Moser Pass At Denali Final Development Plan

REQUEST: The applicant is seeking approval of final development plan and final plat by demonstrating compliance with all conditions of approval that are specifically required. This submittal specifically addresses the incompleteness items included in the October 24, 2023, incompleteness letter.

II. INCOMPLETENESS LETTER ITEMS

Landscape & Forest
Restoration Plans

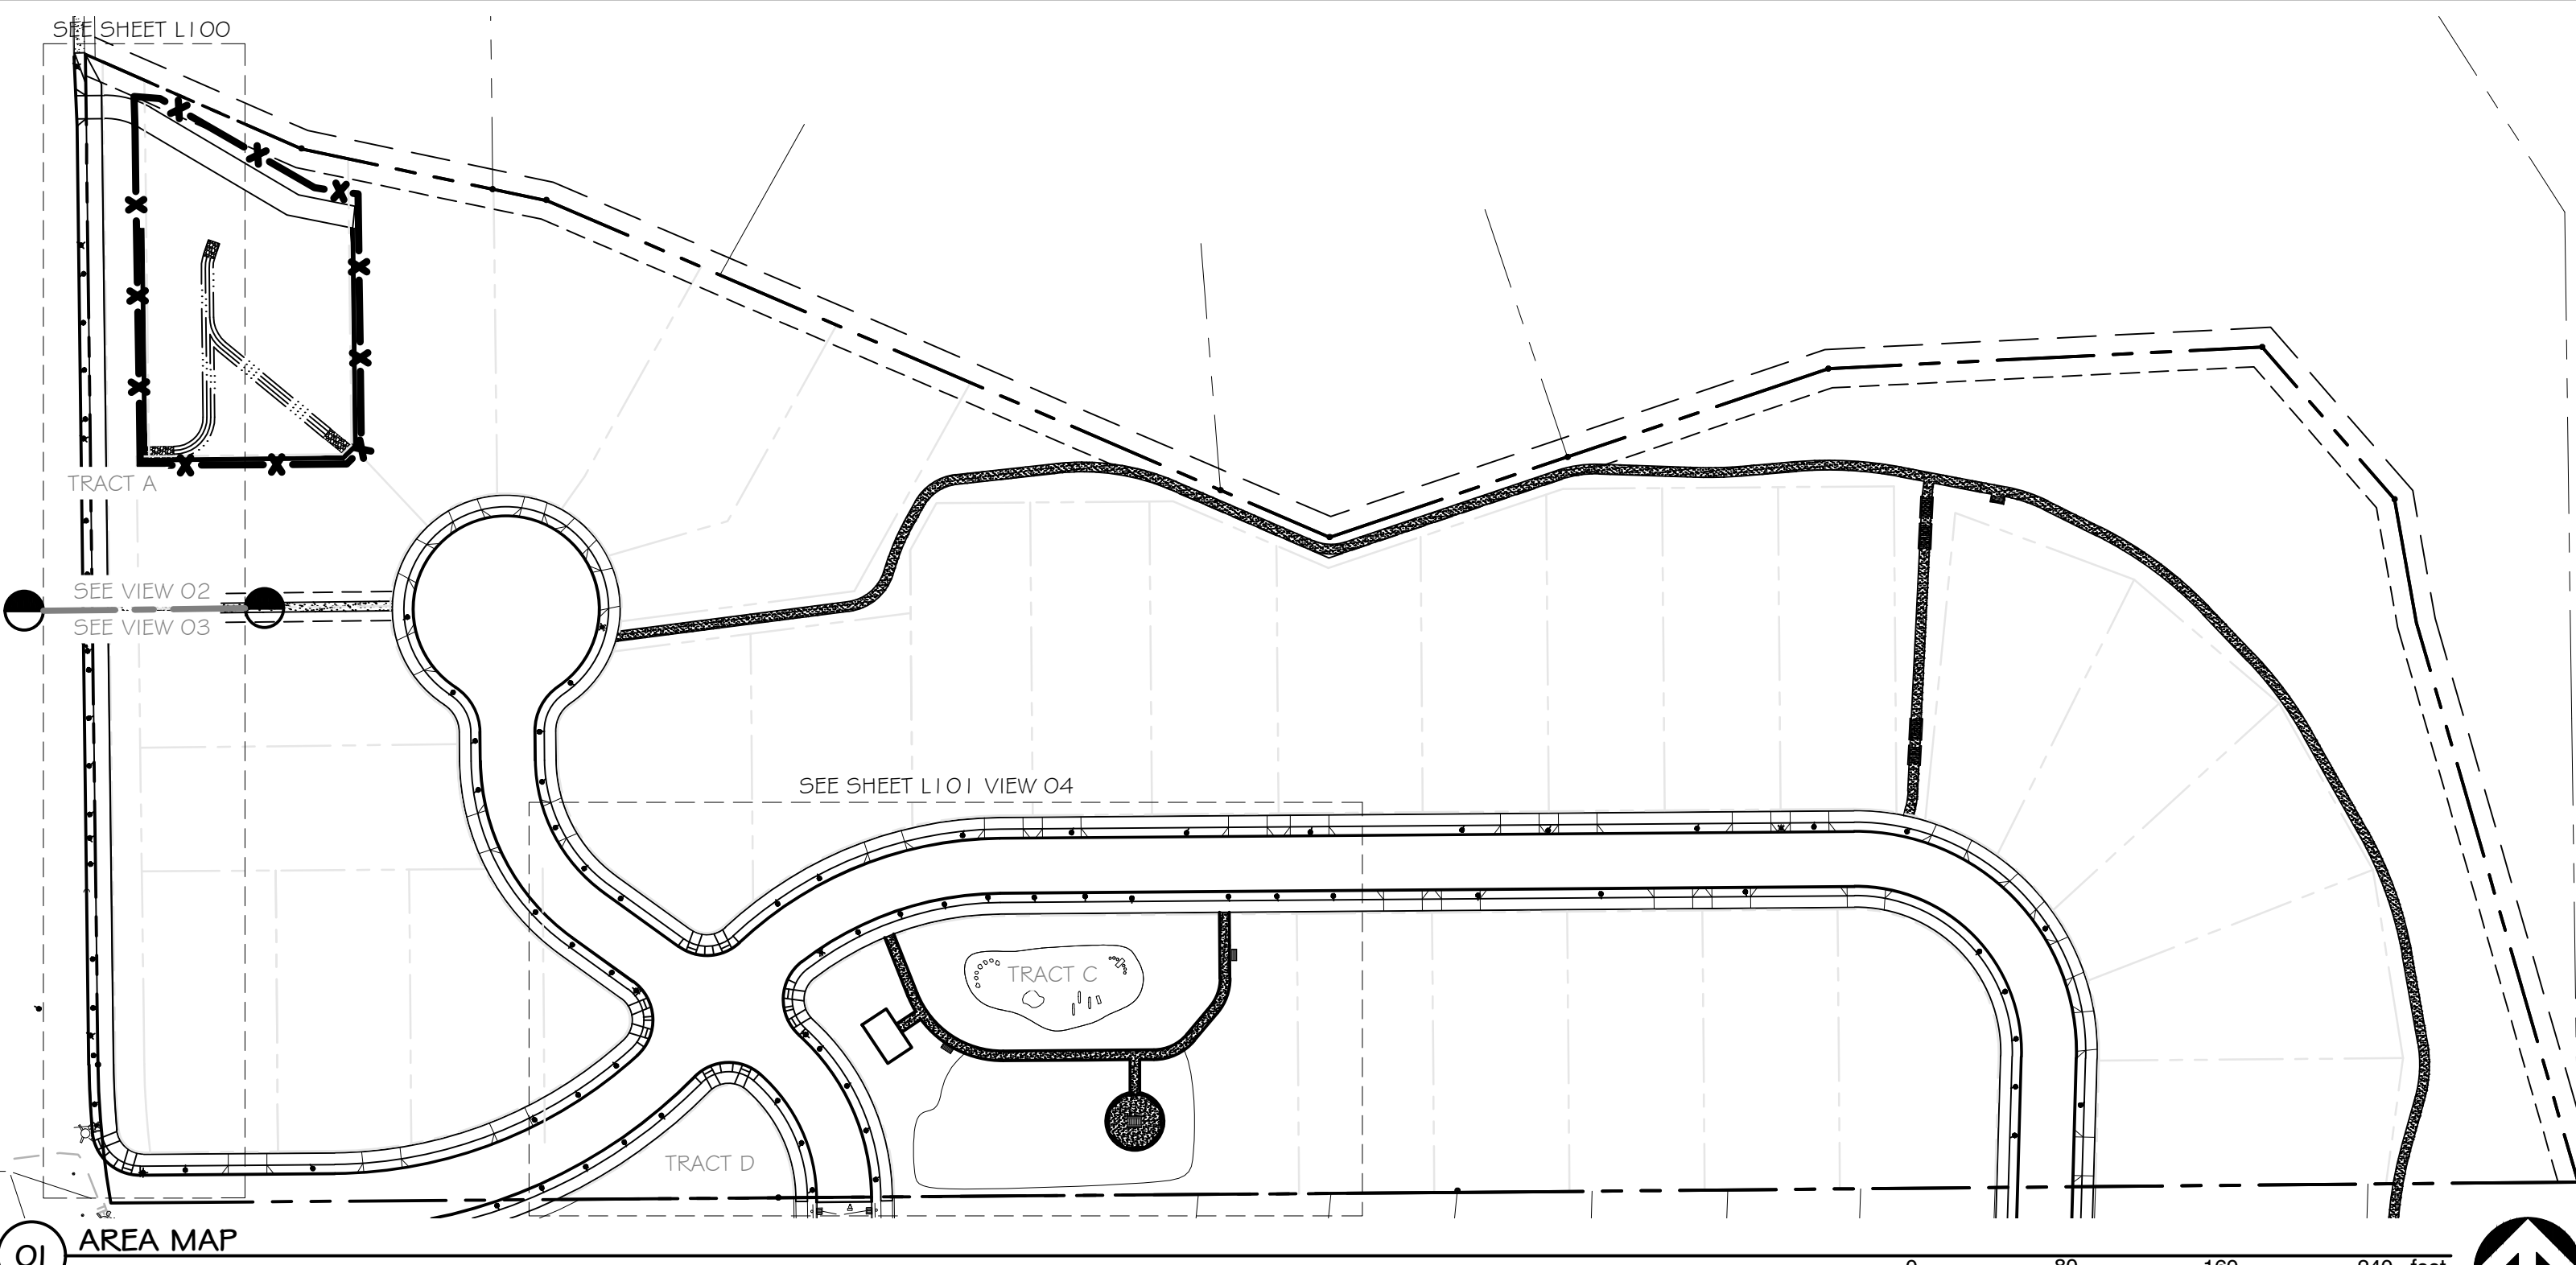
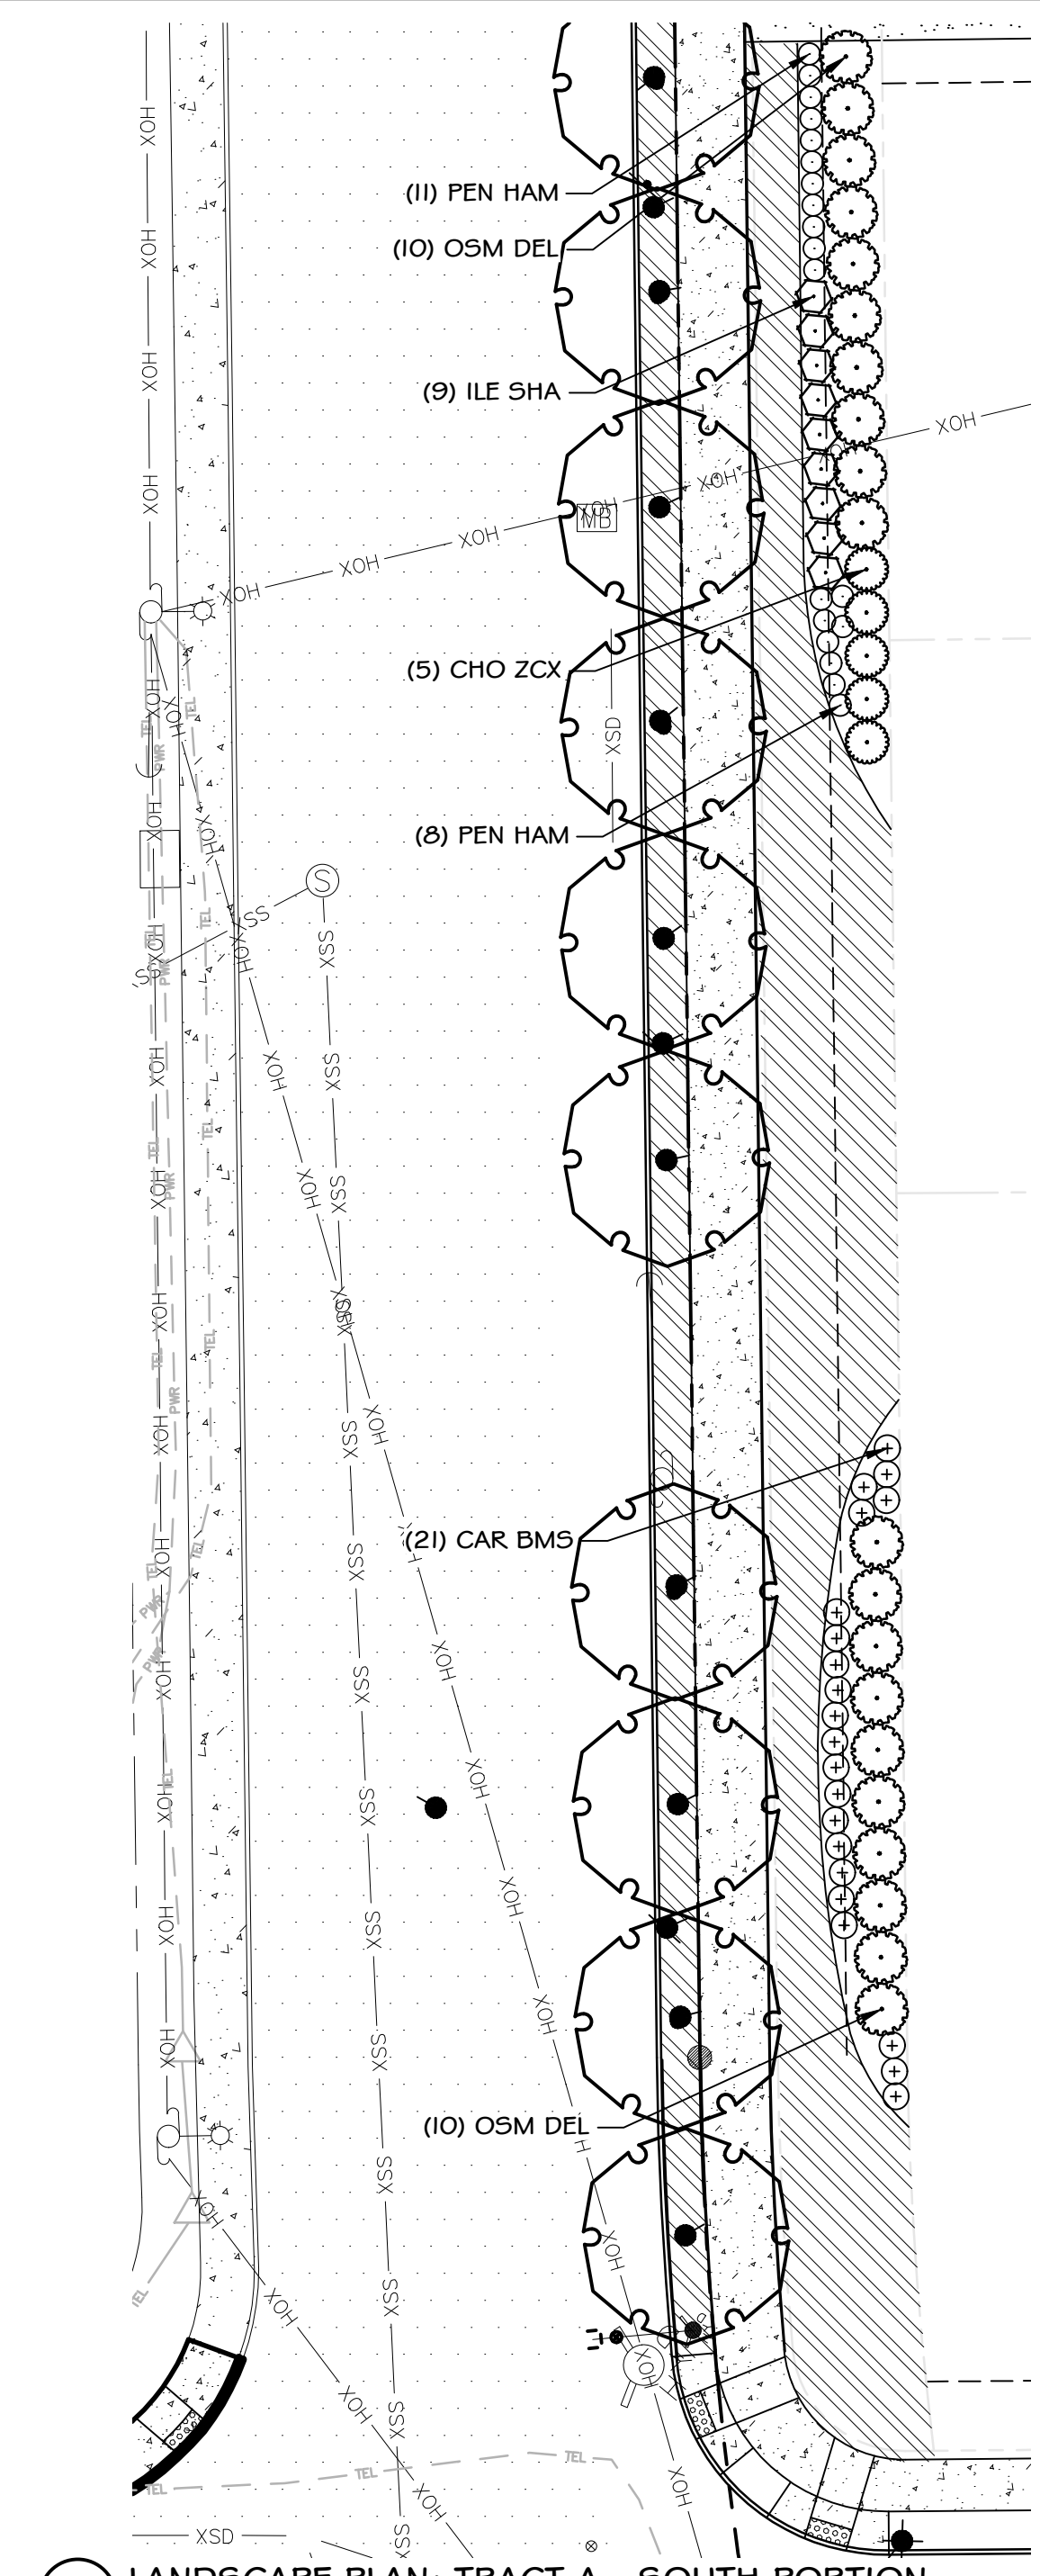
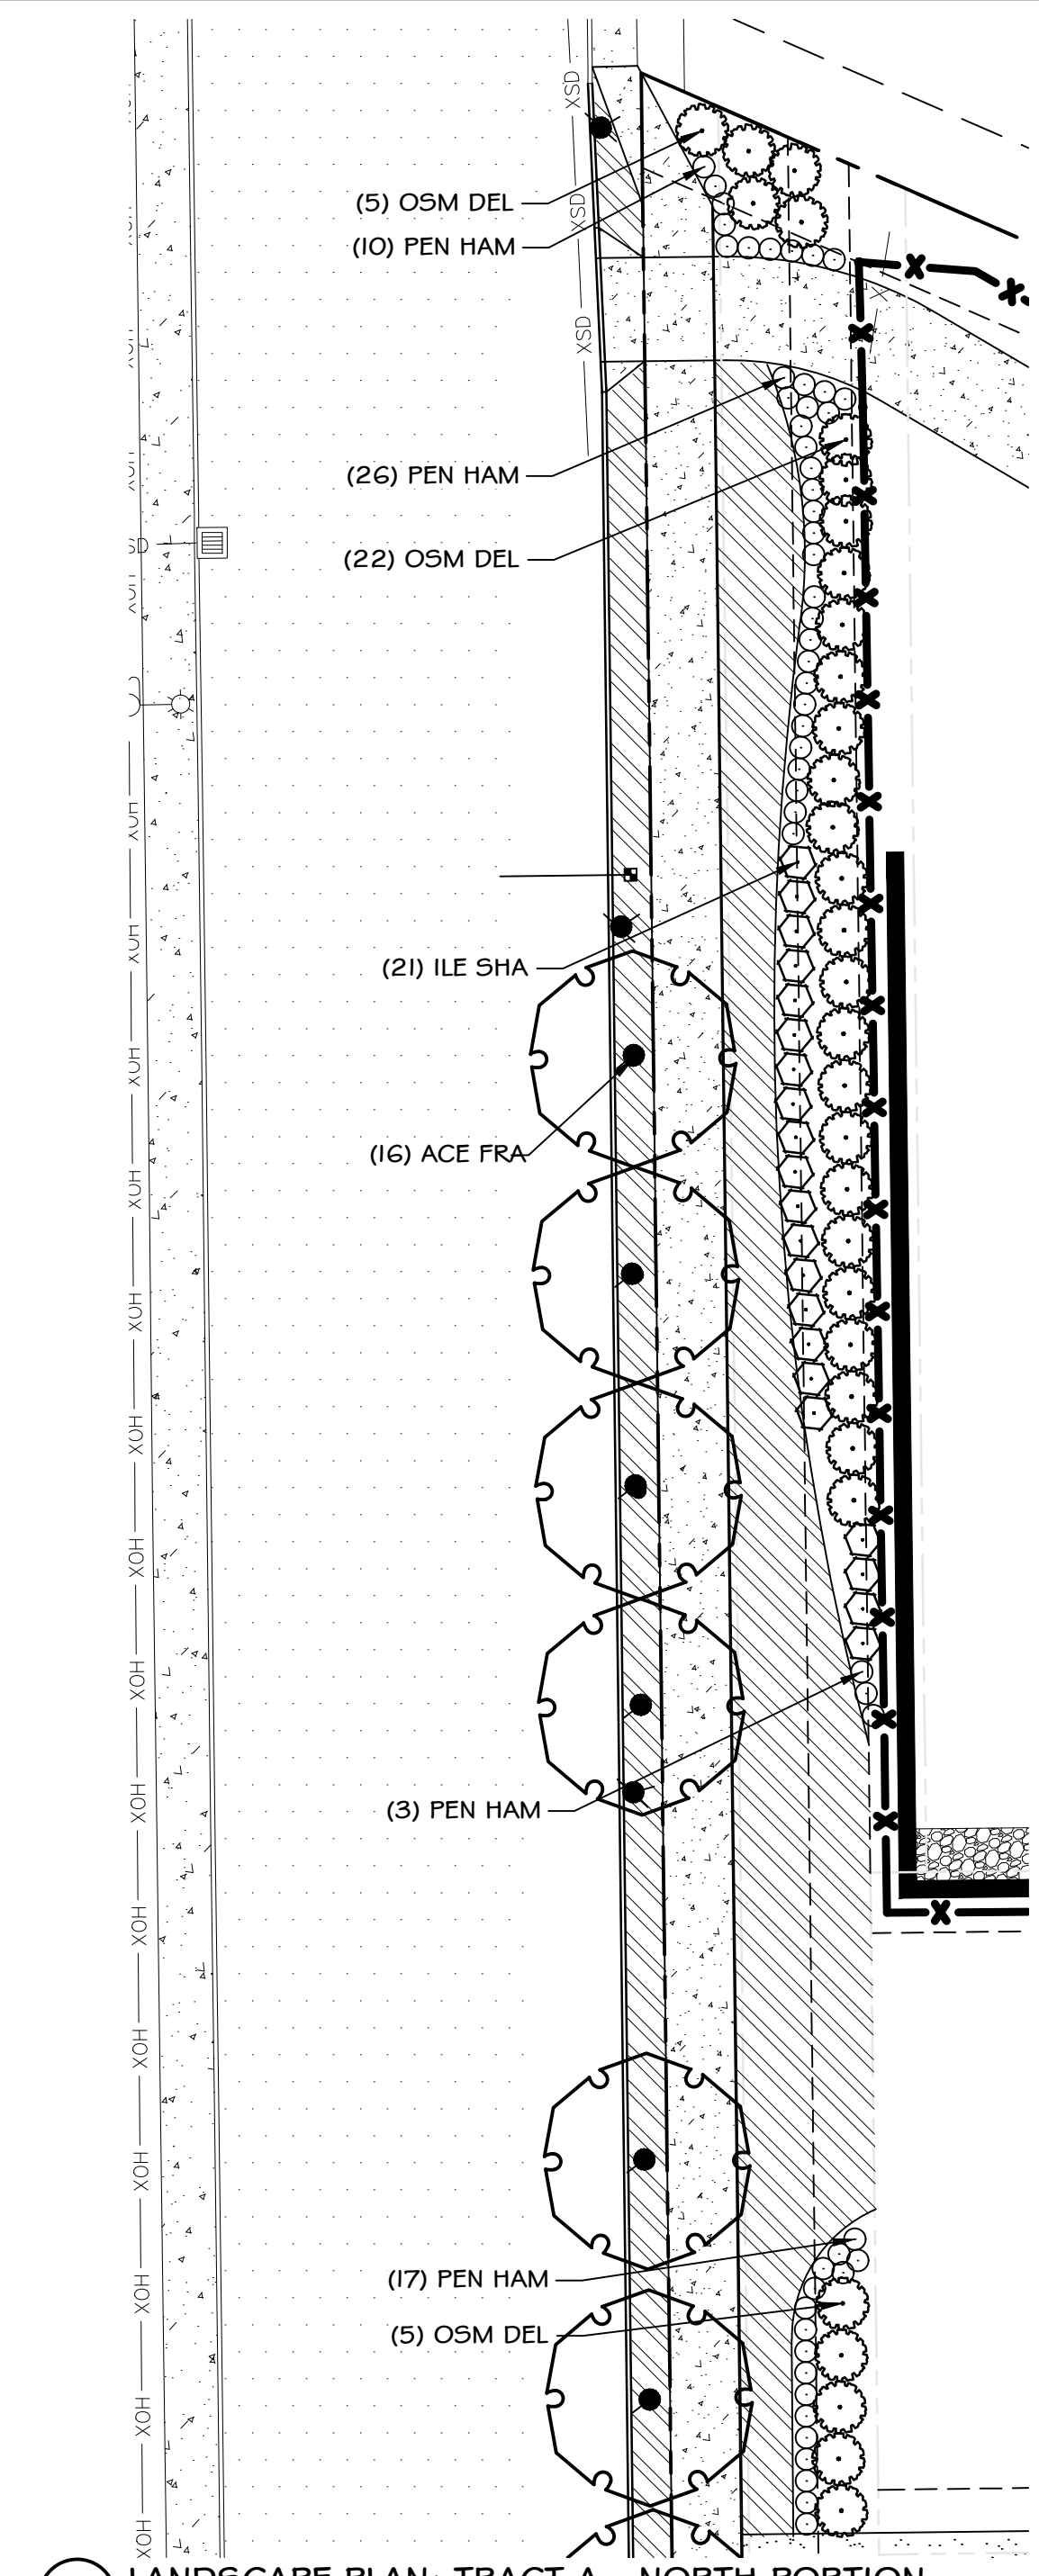
5. Prior to Final Development Plan approval, provide a final Landscape Plan (including open space improvements) and Forest Restoration Plan.

The Landscape and the Forest Restoration Plans must be certified by a licensed landscape architect and a Certified Arborist. Please provide their certification stamps.

Applicant Response: The applicant has included the updated Landscape Plan with appropriate certification information by the required professional. Also included in this submittal is a memo by the project Arborist certifying the Forest Restoration Plan.
